Hi-Fi Products
Service Bulletin

Model: DTC-700 / 75ES

No. 323

Subject: Momentary loss of audio when listening to a tape which was recorded in the LP mode.

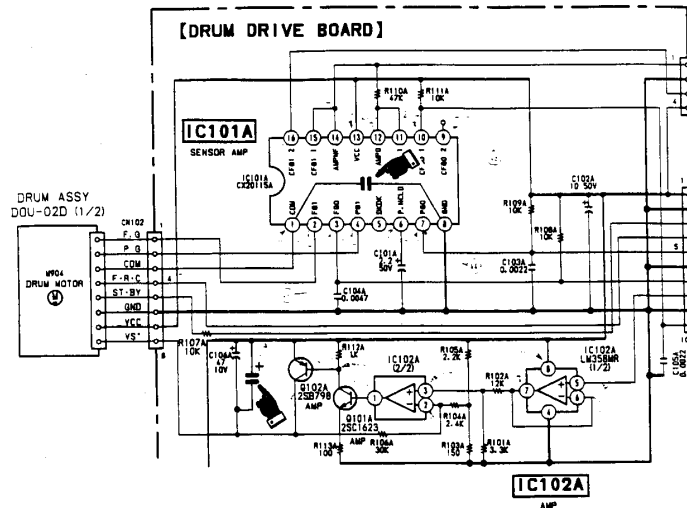
(51) When playing back tapes recorded in the LP mode, dropouts may occur at the same point on the tape. The problem is caused by noise picked up by the FG coil during recording.

Add a 0.01 μ F capacitor between pin 1 and pin 8 of IC101 on the Drum drive board. Add a 100 μ F capacitor in parallel with C106 on the Drum drive board.
Note: The schematic diagram shows C106A for C106.
